| Subject: A/C Compressor Belt Replacement | | | | | | | |
| 485 | A | 09/17/2020 | | | | | |
| P/N: 08-27- | 1357 | Type: Product Integrity | | | | | |

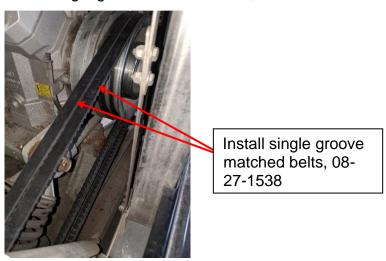
Remove and discard the double groove belt on the AC compressor.

Install single groove matched belts, MCI P/N: 08-27-1538, as shown below.
